METROPOLITAN GOVERNMENT OF NASHVILLE AND DAVIDSON COUNTY

STAFF RECOMMENDATION
310 South 10th Street
June 17, 2015

Application: New construction – addition and outbuilding (not at DADU)
District: Lockeland Springs-East End Neighborhood Conservation Zoning Overlay
Council District: 06
Map and Parcel Number: 08313008900
Applicant: John Werne, Architect
Project Lead: Sean Alexander, sean.alexander@nashville.gov

CARPORT IN REAR

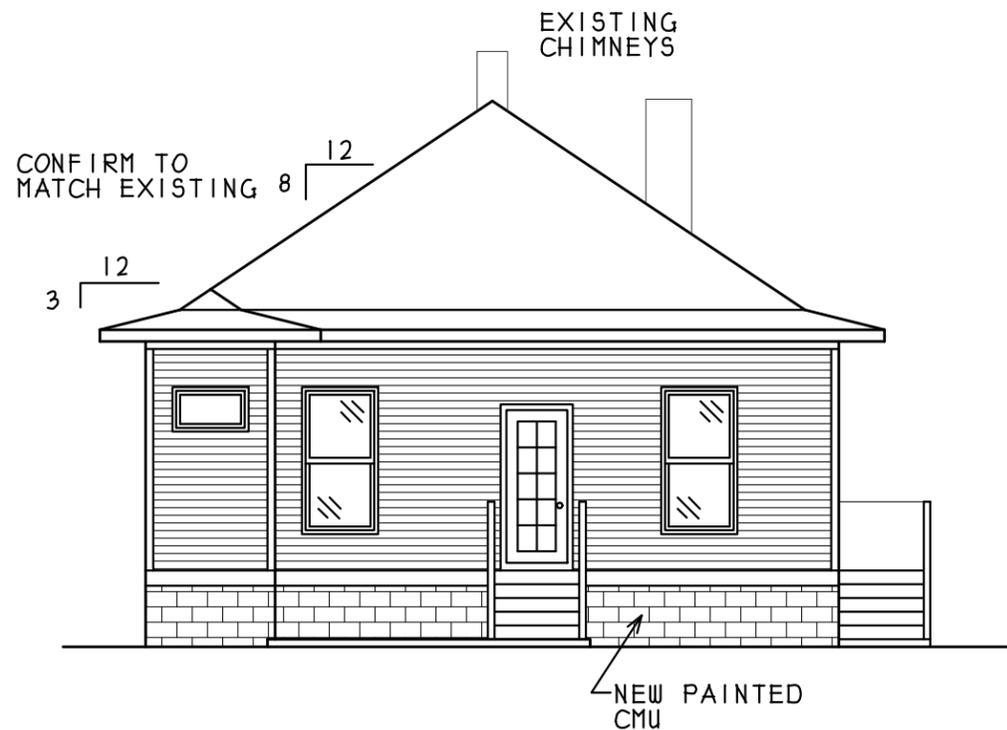
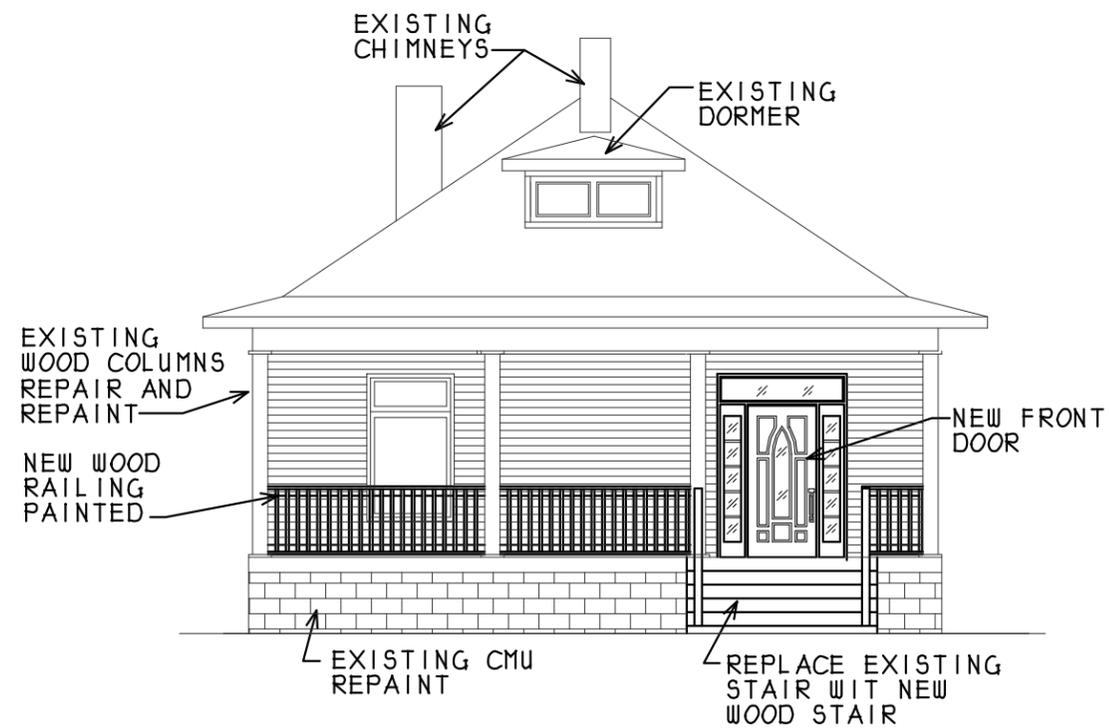
Outbuildings: The application includes a new detached carport at the rear of the lot. The building will be located three feet (3') from the rear property line with side setbacks of twelve feet (12'). This is consistent with the locations of outbuildings historically and meets the bulk zoning setback regulations. The carport will be square, twenty-four feet (24') per side for a total footprint size of five hundred, seventy-six square feet (576 sf). The outbuilding will have wooden columns and the roof will match the asphalt shingle roof on the house. The eave height of the carport will be ten feet (10') and the roof height will be fourteen feet (14'). Staff finds that the proposed outbuilding meets guideline II.B.8.

RIGHT SIDE ELEVATION

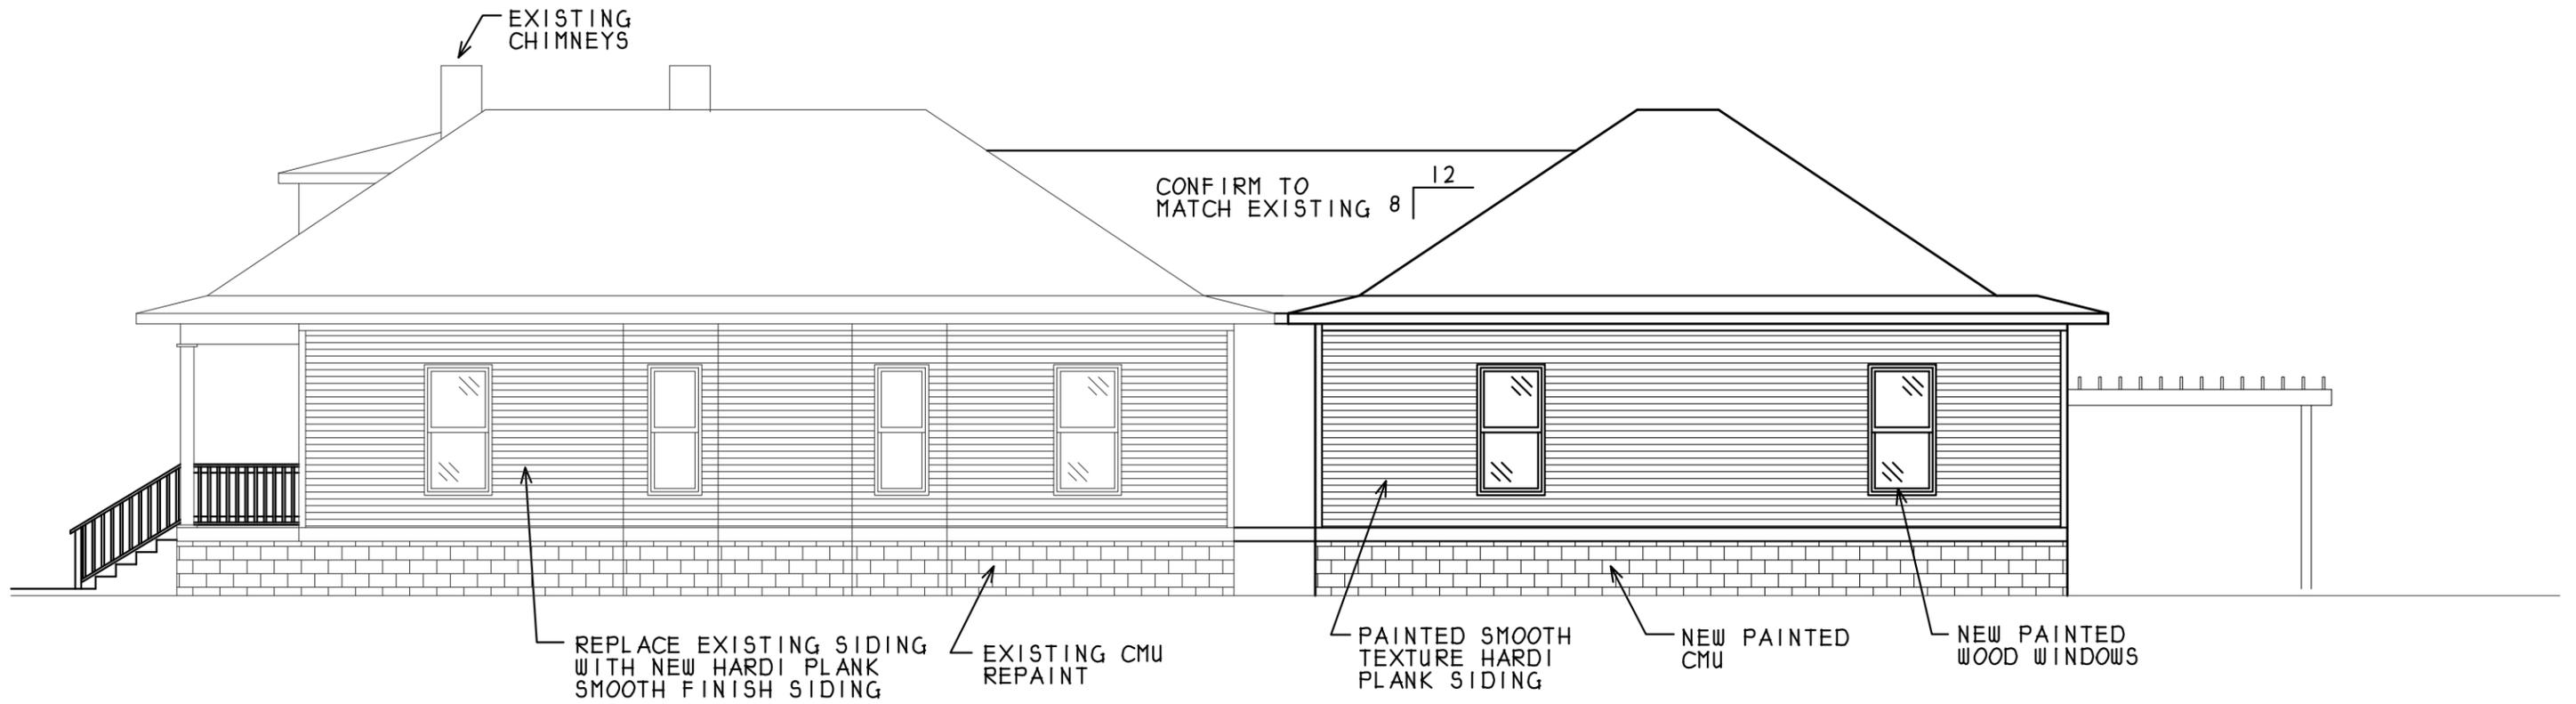
Rhythm and Proportion of Openings: The windows on the house will be generally twice as tall as they are wide. Although the sides of the addition will have some sections of wall greater than ten feet (10') without any opening, they are toward the rear and will not

LEFT SIDE ELEVATION

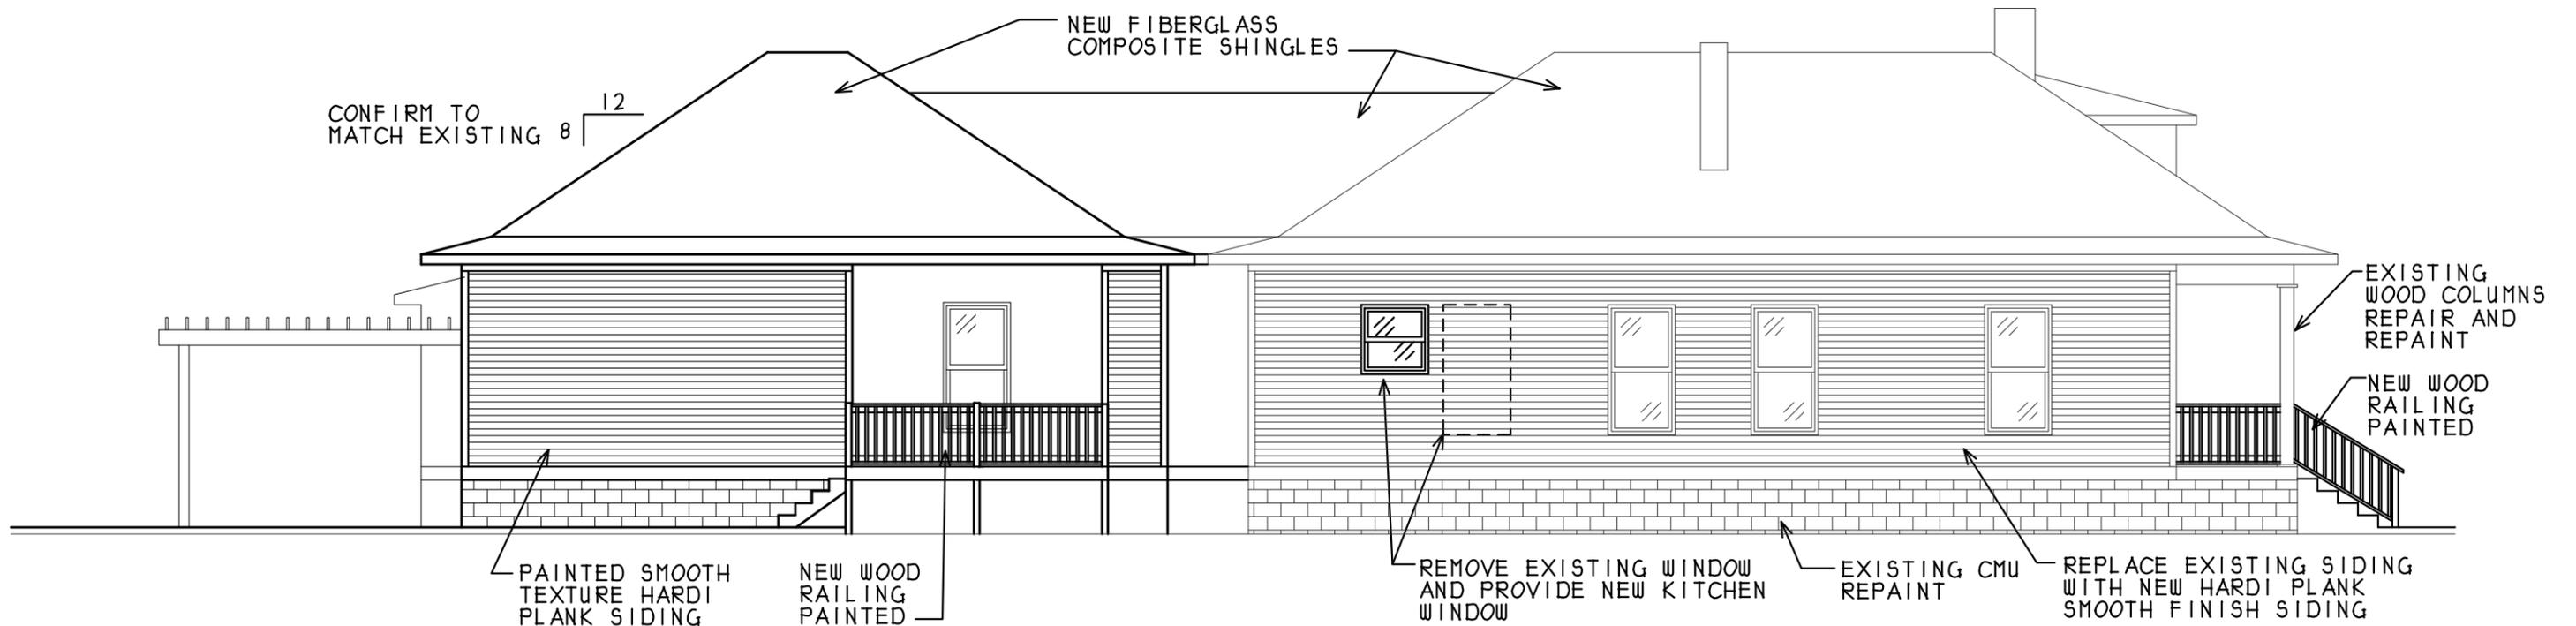
Partial Demolition: The applicant proposes to remove a window on the left side, towards the rear and add a small square window next to the original opening. Typically, the alteration of window or door openings is not appropriate; however, this window is so close to the rear of the home it is not a character defining feature. The applicant will remove a small rear addition, for which demolition is appropriate because it is not an original element. Staff finds this to meet section IV.B.2.a of the design guidelines.

than the hipped roof ridges. The height of the foundation will match the existing foundation height. The addition does not more than double the volume of the existing house. There will be a partially recessed porch on the left side of the addition, recessed ten feet (10') under the main roof and extending four feet (4') to the side yard. The portion of the deck extending to the side will be uncovered, and will not have an impact on the form or character of the historic house. Staff finds the height and scale of the proposed addition, matching that of the historic house, to be compatible and to meet guidelines II.B.1 and II.B.2.
